NOTE: NEW MOUNTING DIMENSIONS FOR MTU4000/5500 GEN5 WALKRAMP GATE WITH 10" FLOOR!

L-401A-IM-MTU4WR GEN5
(MTU-GLR-WR-4000-A-G-CS GEN5 SHEET2)

MTU4-WR TRUCK TRIM (10" FLOOR)
(MTU-GLR-WR-4000-A-G-CS GEN5 SHEET3)

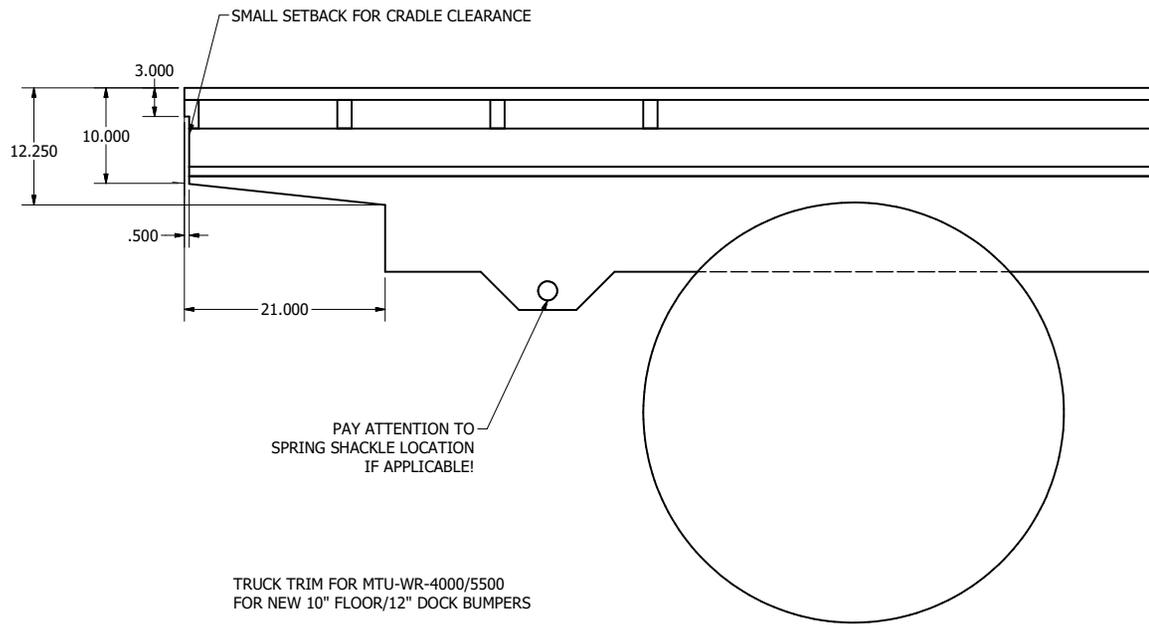
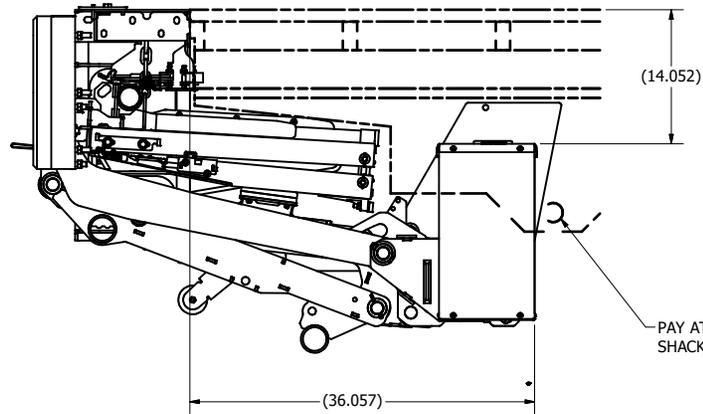
WITH THE SHALLOWER FLOOR EXTENSION, THE DIMENSION FROM THE FLOOR TO THE FRONT OF THE ADAPTER FRAME TUBE IS DIFFERENT FROM A NON-WALKRAMP MTU4. THE VERTICAL DIMENSION IS THE SAME. ARM LENGTH, BED RANGE, AND GROUND CLEARANCE ARE ALL THE SAME.
